HOPE CREEK GENERATING STATION
DOCKET NO. 50-354
DRAFT SAFETY EVALUATION REPORT
OPEN ITEM STATUS

Attachment 1 is a current list which provides a status of the open items identified in Section 1.7 of the Draft Safety Evaluation Report (SER). Items identified as "complete" are those for which PSE&G has provided responses and no confirmation of status has been received from the staff. We will consider these items closed unless notified otherwise. In order to permit timely resolution of items identified as "complete" which may not be resolved to the staff's satisfaction, please provide a specific description of the issue which remains to be resolved.

In addition, enclosed for your review and approval (see Attachment 4) are the resolutions to the Draft SER open items and the resolution of comments received during the April 17 and 18, 1984, Power Systems Branch (Mechanical) meeting on the 430 questions series, listed in Attachment 3. A signed original of the required affidavit is provided to document the submittal of these DSER open item and FSAR question responses.

FIGURE 8-3-16
SHEETS OF 8

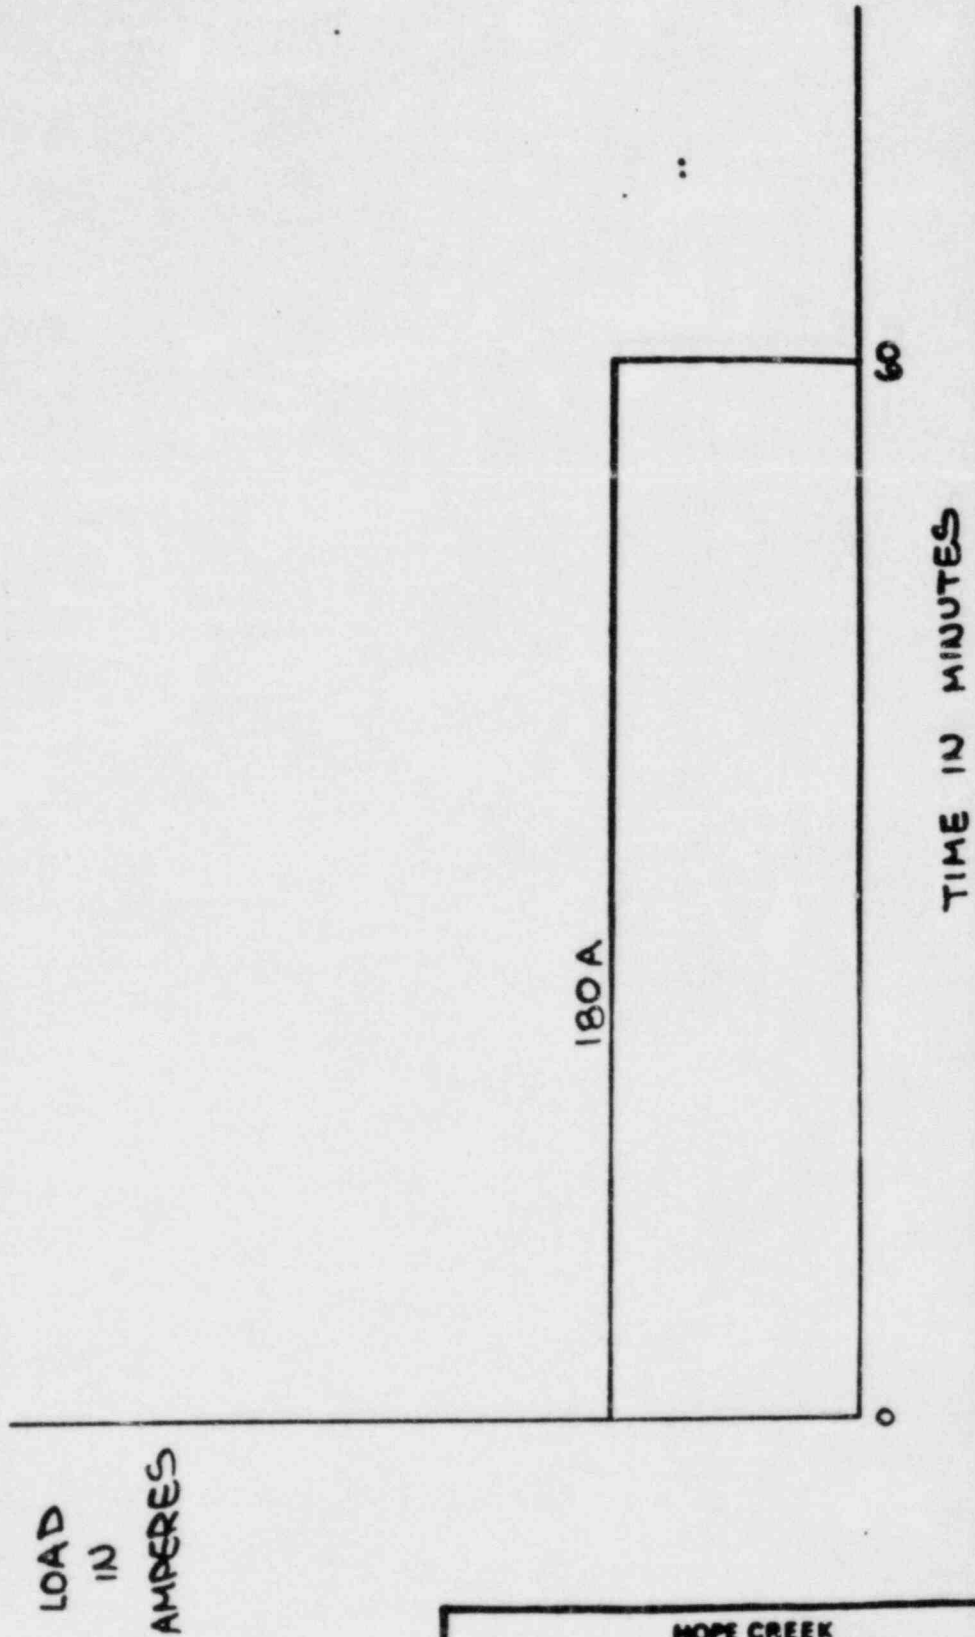
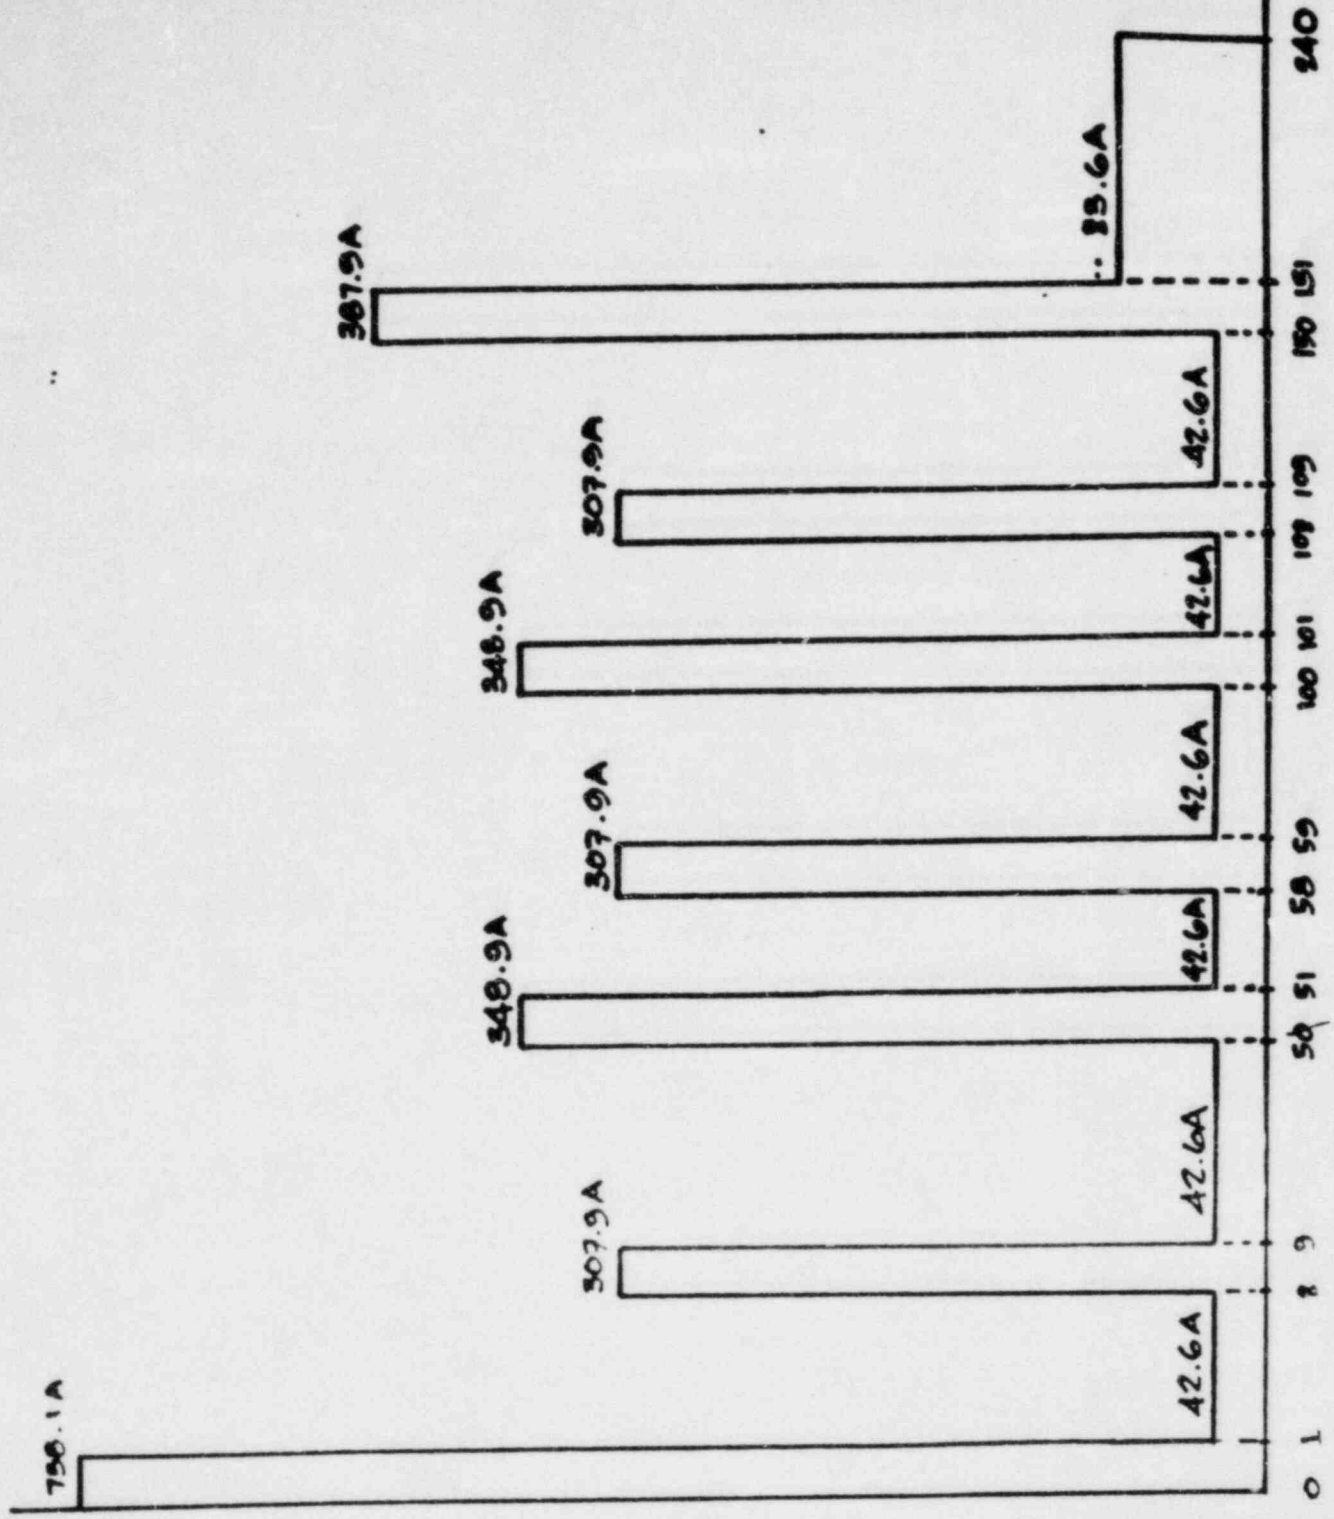
RESPONSE

Tables 8.3-7a,b,c, and d, have been revised to change the 13 seconds to 1 minute.

FIGURE 4-10 78-1 AMENDMENT 4-1

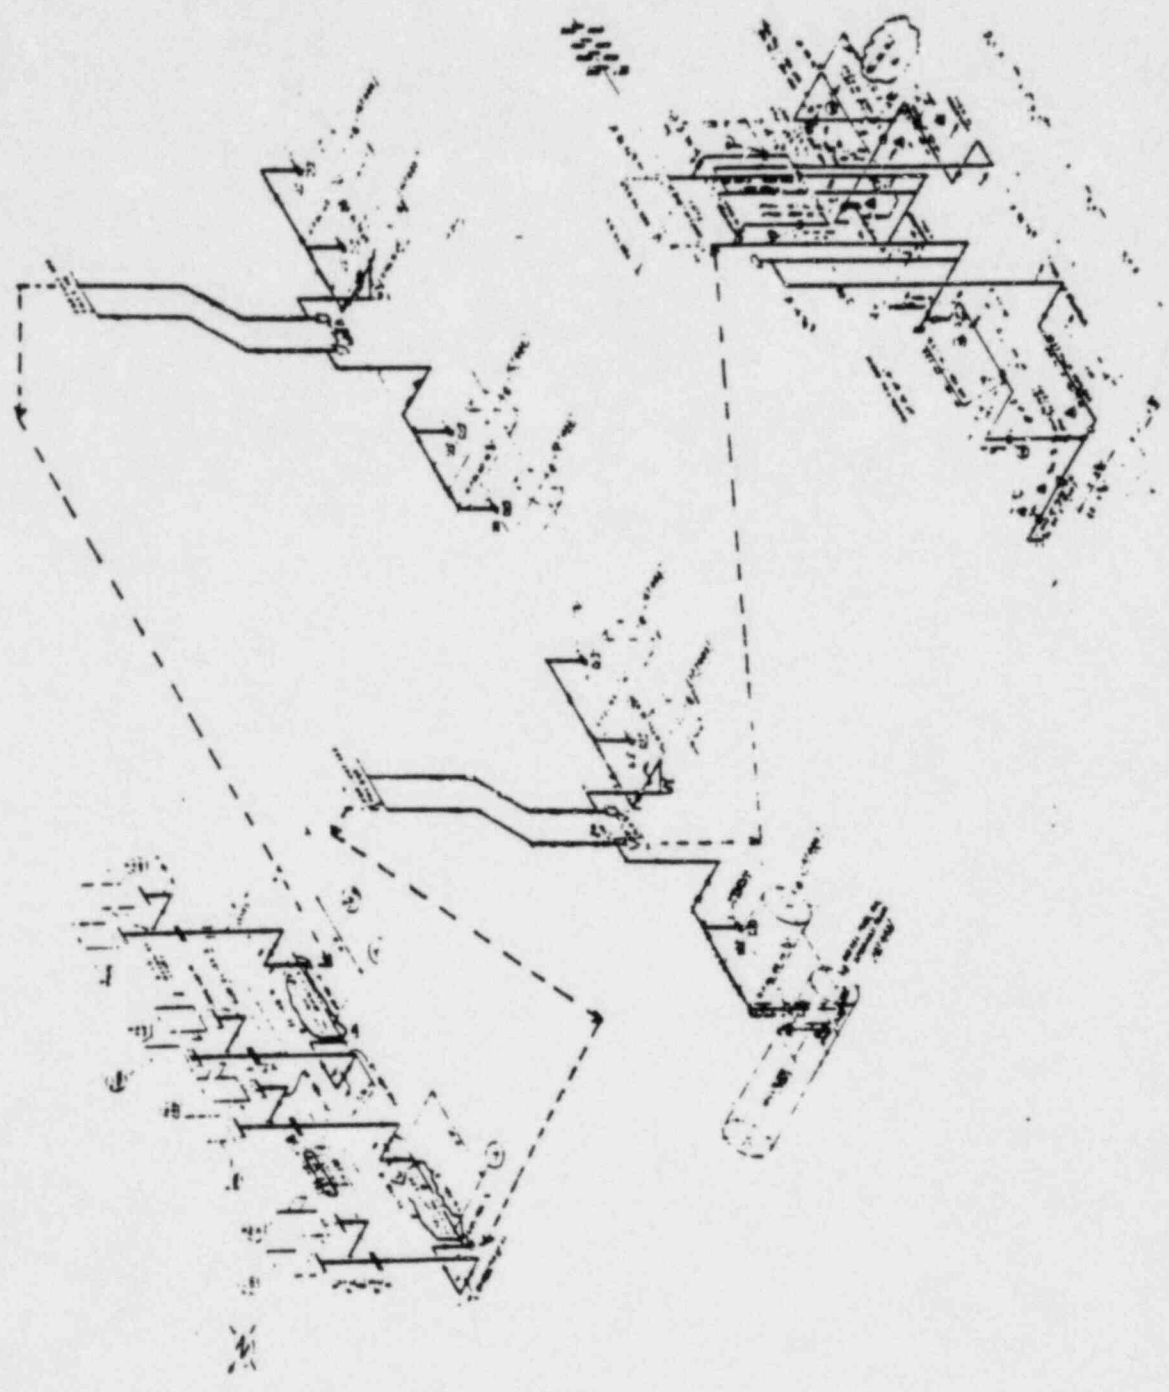
430.78 TORNADO MISSILE PROTECTION OF FUEL OIL STORAGE AND DRY
7.5.4) TANK VENTS IS INADEQUATE.

The standby diesel generator fuel oil storage tank vents are located in the standby diesel generator area of the auxiliary building except for the conservation vent and flame arrestor. The portions of the vent lines that are located in the diesel generator area of the auxiliary building are protected from tornado missiles as described in revised Sections 9.5.4.3, 3.3, and 3.5. The section of piping that is located outside of the standby diesel generator area of the auxiliary building, as shown on Figure 430.78-1 are not missile protected. ~~If the vent line should become damaged by a tornado missile, appropriate actions will be taken to establish an alternate vent path until the normal vent path is returned to its operable condition.~~

Figure 430.142-1

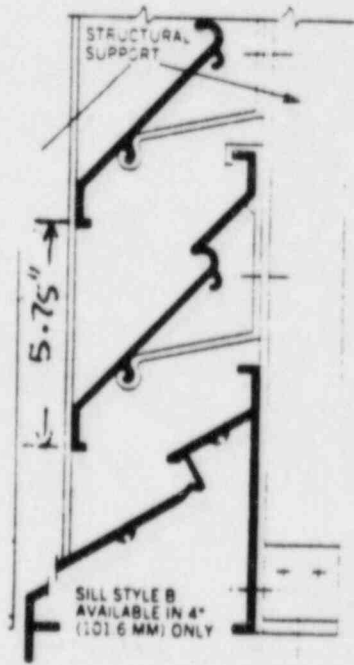
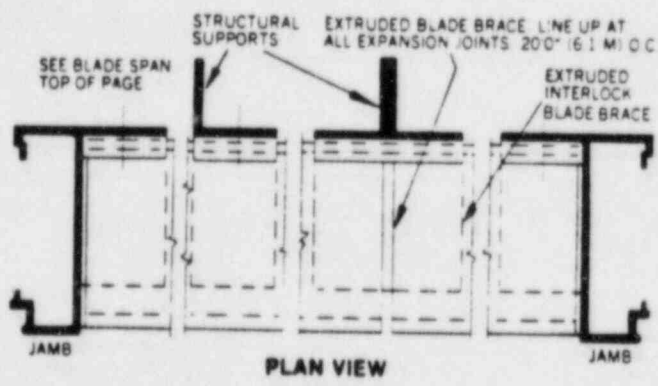
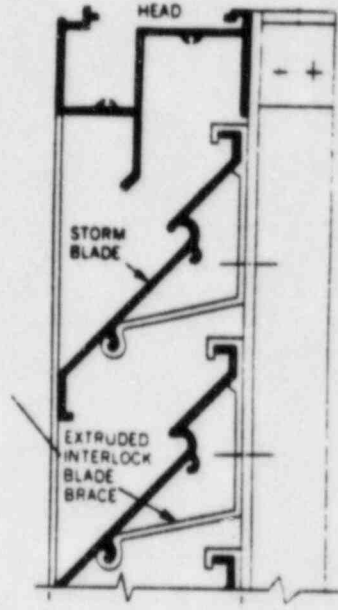
As discussed in Section 9.5.8.3 and shown
in Figure 1.2-11 the combustion air for
506 is outside air drawn through low
openings in the south wall of the A
Building at elevation 130 ft. ~~The~~ ^{Each} exhaust
duct discharges above the auxiliary building
at elevation 198 ft and is about ~~75~~ ⁷⁵ ft
north from ~~the~~ ^{each} of the associated air intake ~~openings~~ ^{openings}.
combination of ^{much} higher ^{elevation} hot temperature exhaust
lower ^{elevation} cold air intake and the general
separation of ~~these~~ ^{these} ~~lines~~ ^{lines} will inhibit any
recirculation ~~back~~ ^{to} ~~test~~

shaped hood, which has a minimum
two foot overhang.
